Planning Amendment: North Link Façade Updates\_DRAFT

Document number: BEMP-HBA-P1-ZZ-SK-A-00-1048  
Issue date: 11.08.2023  
Revision: P01

This document describes the proposed design amendment to Plot 1’s north ‘link’ facade highlighted opposite - an update to the size and setting out of the windows and brick piers at levels 00 and 01.

Fig. 1\_Planning approved scheme\_extract of Plot 1 north ‘link’ elevation  
The current windows at levels 00-01 exceed the size criteria set out in the official fire test data (extract in fig. 2 below)

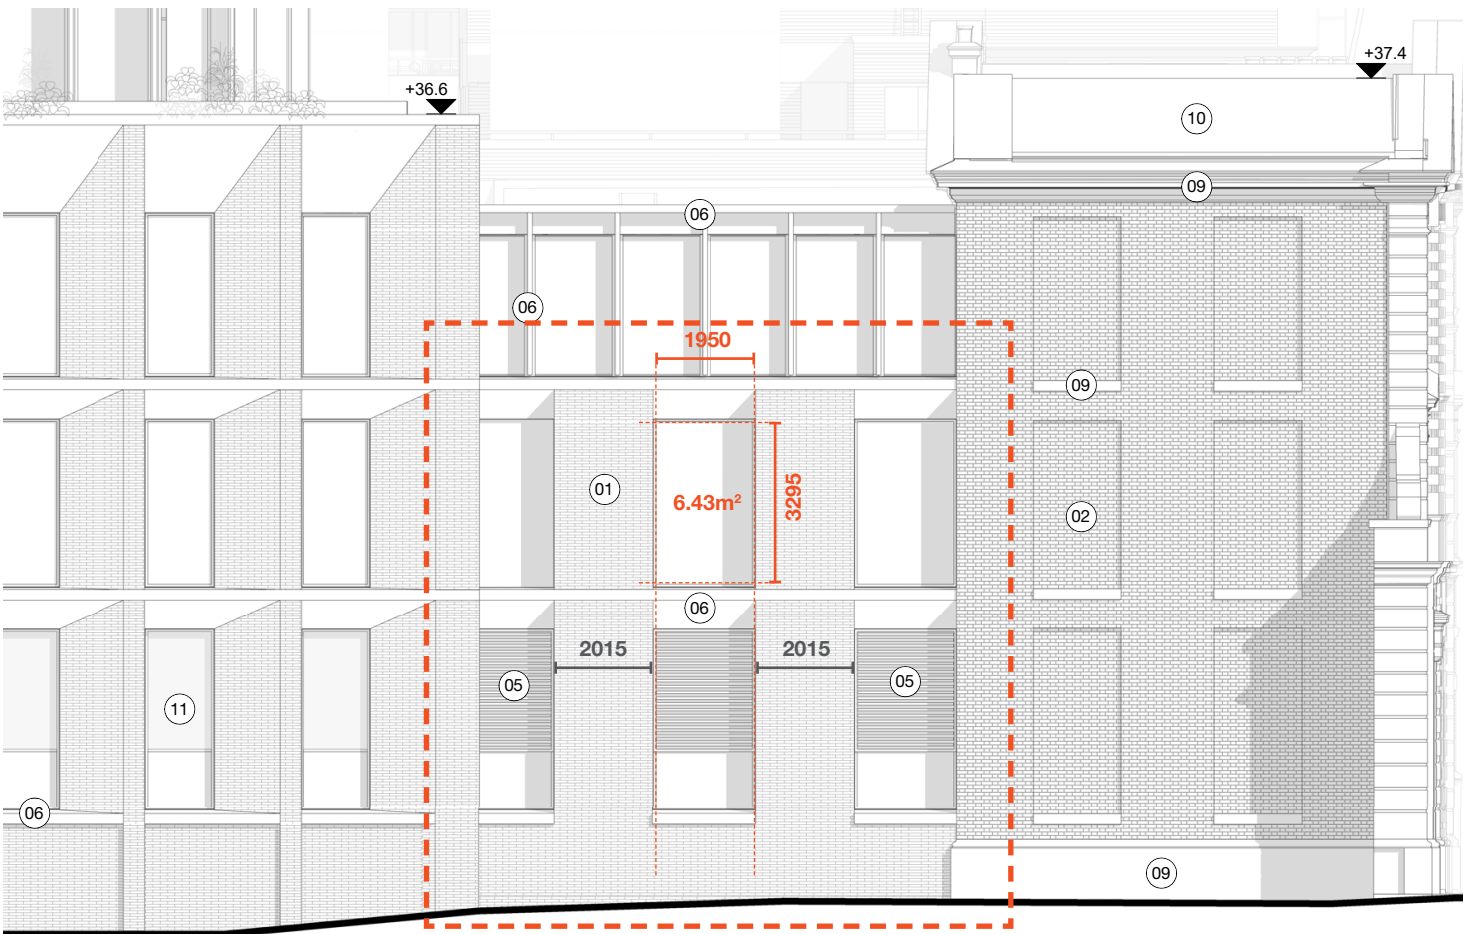
Following a detailed technical review, the specialist facade subcontractors have advised that the north link windows in the current planning approved scheme (highlighted in fig.1) do not fully satisfy the size criteria set out in the fire test report:

- Level 00 north link windows exceed the specified width criteria
- Level 01 north link windows exceed the width and area criteria

- Increase the width of the 2no. central brick piers at levels 00-01 by 3no. bricks in order to;
- Reduce the width of the windows to ensure the glass width falls within the max. 1800mm limit. This width reduction will also ensure the overall glass area falls within 5.45m².
- The window height remains as per the approved scheme

Drawing ref: BEMP-HBA-P1-ZZ-DR-A-20-1211 Plot 1 North Elevation - Proposed

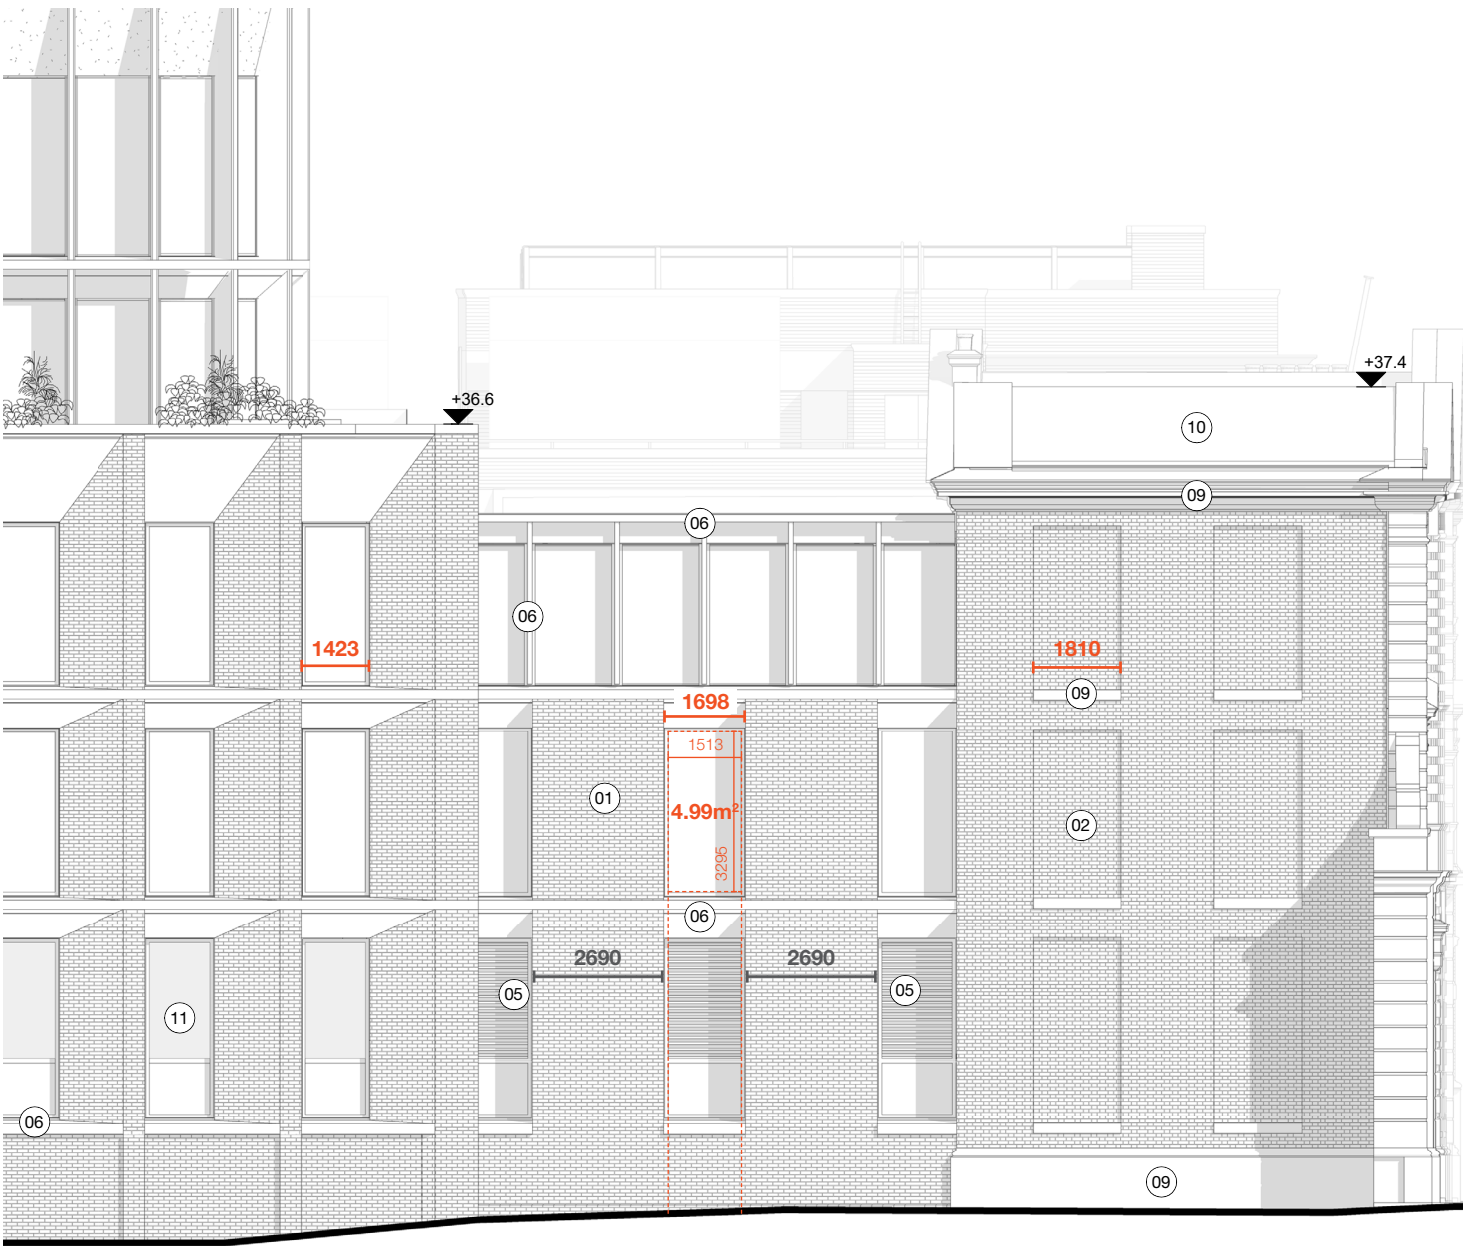
- Level 00 link building windows exceed the specified width criteria
- Level 01 link building windows exceed the width and area criteria

- Increase the width of the 2no. central brick piers at levels 00-01 by 3no. bricks in order to;
- Reduce the width of the windows to ensure the glass width falls within the max. 1800mm limit. This width reduction will also ensure the overall glass area falls within 5.45m²
- The proposed amendment maintains equal and symmetrical spacing to the windows and brick piers as per the planning approved scheme

Drawing ref: BEMP-HBA-P1-ZZ-DR-A-20-1211 Plot 1 North Elevation - Proposed

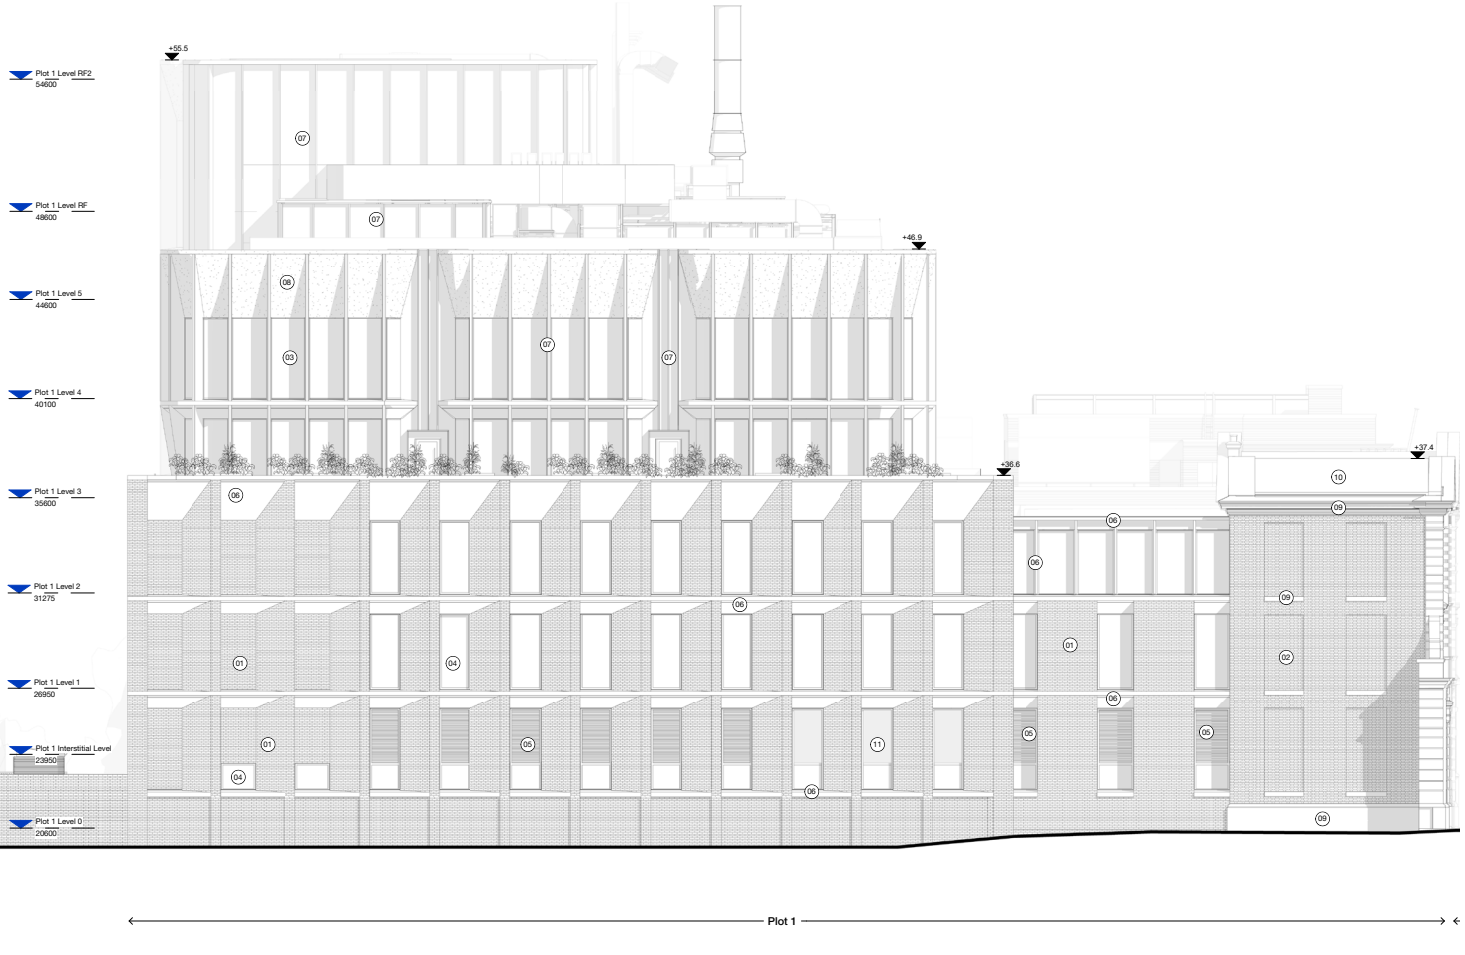
- Level 00 link building windows exceed the specified width criteria
- Level 01 link building windows exceed the width and area criteria

- Increase the width of the 2no. central brick piers at levels 00-01 by 3no. bricks in order to;
- Reduce the width of the windows to ensure the glass width falls within the max. 1800mm limit. This width reduction will also ensure the overall glass area falls within 5.45m<sup>2</sup>
- The proposed amendment maintains equal and symmetrical spacing to the windows and brick piers as per the planning approved scheme
